Water & Wastewater Planning Review Weinam Creek Priority Development Area

PREPARED FOR REDLAND INVESTMENT CORPORATION

ISSUE	DATE	ISSUE DETAILS	AUTHOR	CHECKED	APPROVED
A	07.04.2020	Final	T. Chalmers	D. Collins	T. Chalmers

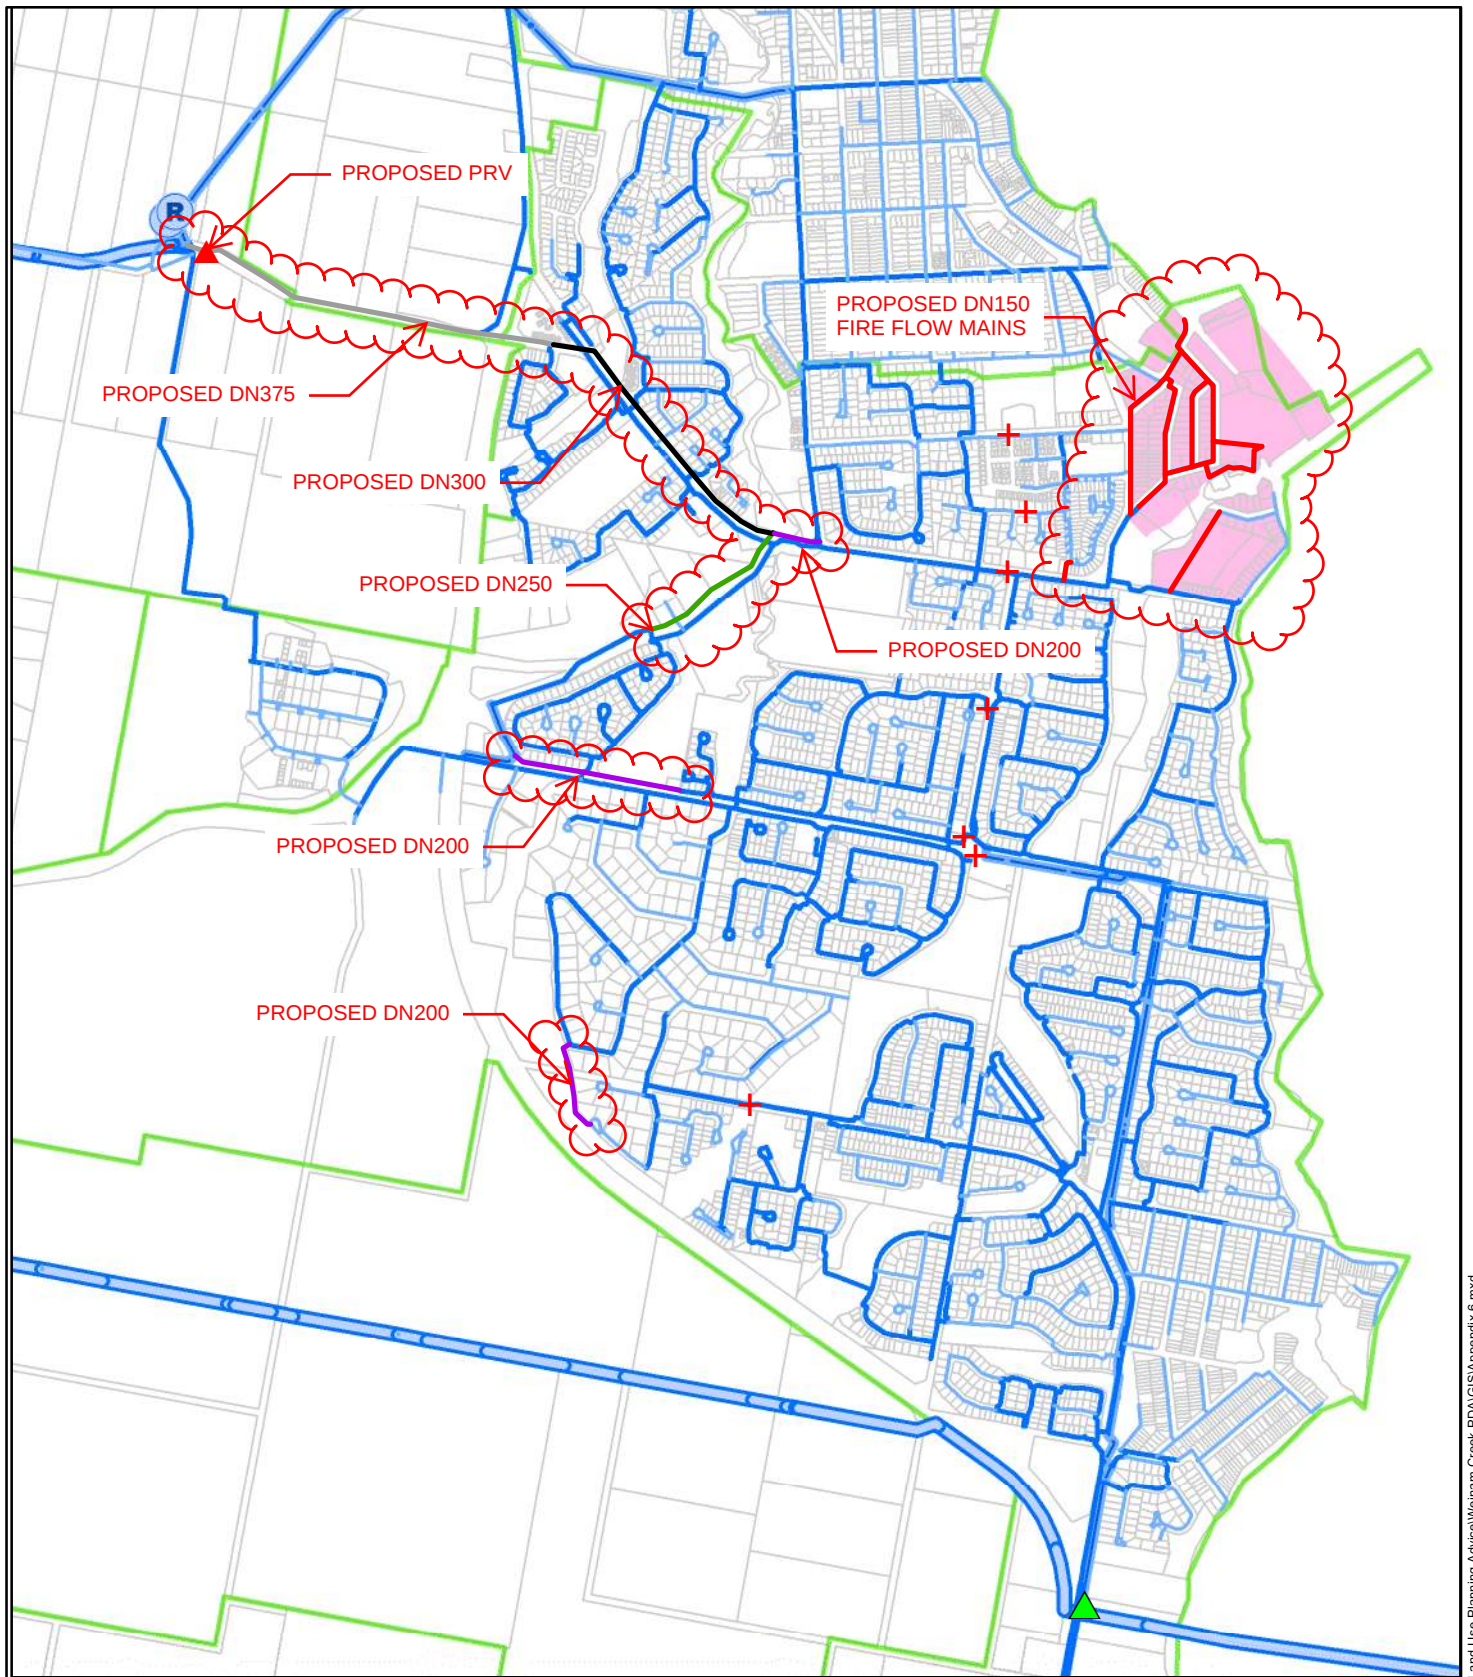
- o Option 2 – Split Serpentine Creek DMA with a new supply point from the DN600 along Giles Road.
- Both options resolve pressure deficiencies, however Option 2 was found to be favourable based on a lower RCC capital cost estimate of \$3.6M versus \$4.5M for Option 1.

Both options are included within Appendix B, with Option 2 the preferred servicing strategy. On the basis that Option 2 is the preferred strategy, Option 1 will not be discussed any further within this report.

Item	RCC Proposed Augmentation	Trigger	Calibre Comments
1	1,135m of DN375 Water Main	PDA Maximum Day Demands	Agreed, critical connection to trunk main required to achieve minimum pressure requirements. Existing network is undersized to cater for PDA demands. Note, 260m of DN150 augmentations triggered by Maximum Day Demands are in addition to Fire Flow augmentations below.
2	830m of DN300 Water Main		
3	420m of DN250 Water Main		
4	640m of DN200 Water Main		
5	260m of DN150 Water Main		
6	PRV / Meter Assembly		
7	200m of DN200 Water Main	PDA Fire Flows	Reticulation augmentations are reasonable considering fire flows have increased from 15 L/s to 30 L/s.
8	1,250m of DN150 Water Main
